**DEPARTMENT OF TRANSPORTATION  
STATE OF GEORGIA**

**FILE:** STP-1267(8) Oconee  
P.I. No.: 142060  
S.R. 53 Widening and Reconstruction

**SUBJECT: IMPLEMENTATION OF VALUE ENGINEERING STUDY ALTERNATIVES**

S. R. 53/MARS HILL RD/OCONEE CONNECTOR  
YEAR 2029 (BUILD) PEAK HOUR TRAFFIC  
TRAFFIC DIAGRAM (w/o Shop Ctr. signal)

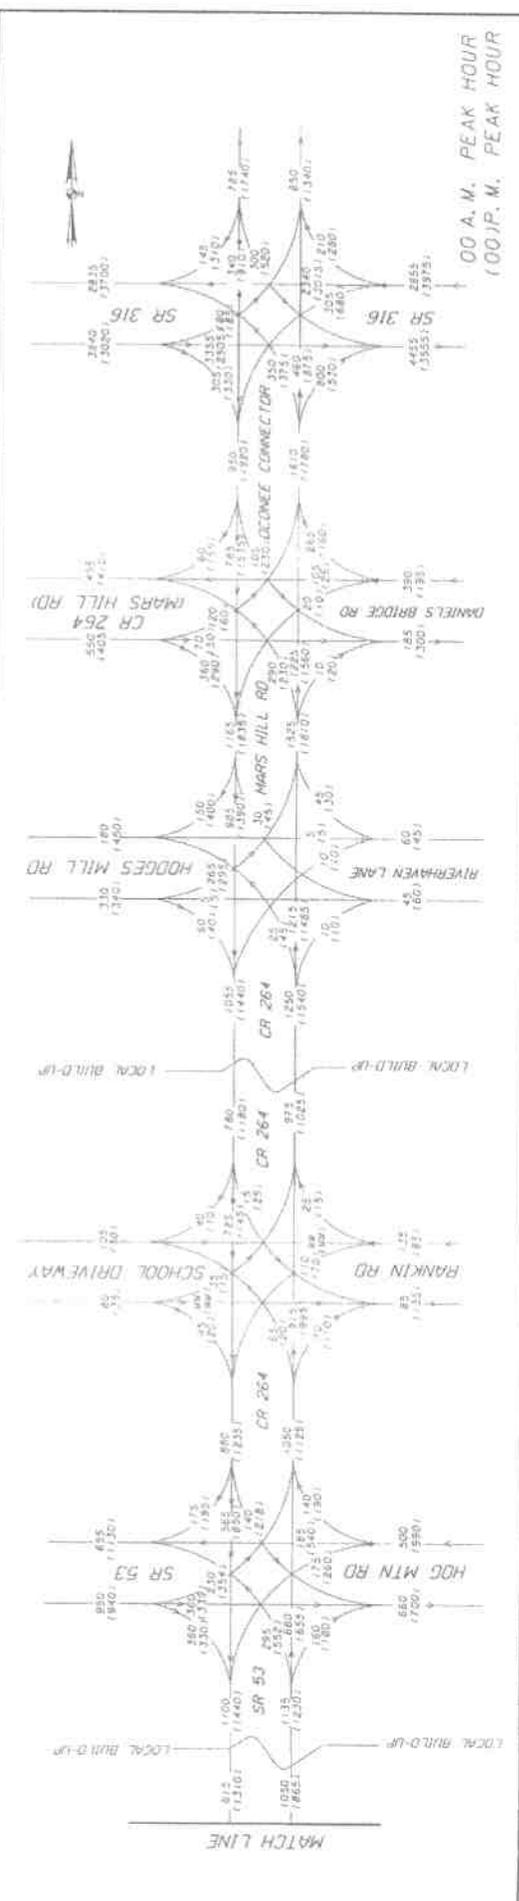
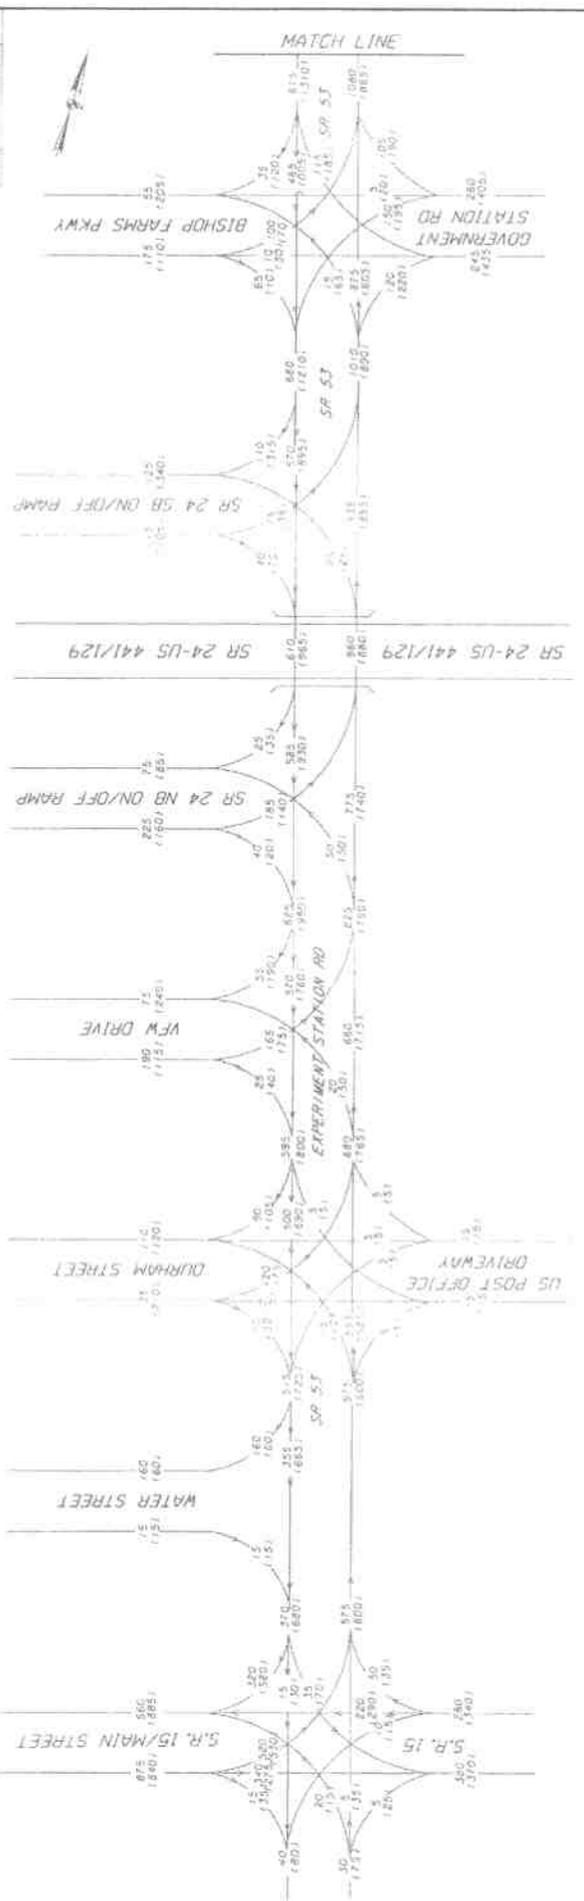
PROJECT:	STP-1267(8), P.I. No. 142060					
	SR 53 / MARS HILL RD / OCONEE CONNECTOR					
	Oconee County, GDOT district 1					
	Final Design Stage					
	VE Implementation Alternative No. 26					
DESCRIPTION:	ELIMINATE PROPOSED TRAFFIC SIGNAL AT MCDONALD'S/PUBLIX SHOPPING CENTER					
<u>ADVANTAGES:</u>				<u>DISADVANTAGES:</u>

1) Reduces construction cost.				1) Removing the signal results in increased left/U-turn movements and lower LOS for the S.R.53/Hog Mtn. Rd intersection and delays through traffic. 2) Proposed signal meets traffic signal warrants. 3) The businesses within the two shopping centers are front-oriented and mostly face S.R.53/Exp. Station Rd. The resulting decrease in access will make right-of-way acquisition costs increase.		
<u>PROJECT INFORMATION:</u>						
SPEED DESIGN	45 MPH					
PEAK HR. TRUCK %	8					
ADT (2009)	18,800					
ADT (2029)	33,400					
<u>DISCUSSION:</u>						
<p>By closing the median at the Publix Shopping center entrance and eliminating the proposed signal, NB vehicles who want to access the shopping center must continue NB to the S.R.53/Hog Mtn. Rd. intersection and make a U-turn. This extra volume of traffic causes that intersection to go from a LOS D to a LOS E.</p> <p>Also by forcing NB vehicles to make a U-turn to access the shopping center, shops within the center may anticipate a decline in business sales and will not be in favor of the project, causing right-of-way acquisition to be delayed and costly. This right-of-way acquisition cost is anticipated to exceed any cost savings.</p>

Response: A signal for this intersection is warranted mainly for the 175 DHV left turn movements from Durham Street to S.R. 53. Also, removing the signal would force vehicles to cross all 5 lanes of traffic on S.R. 53 from the post office/jail driveway to Durham Street. Removing the signal would make this intersection dangerous to maneuver.
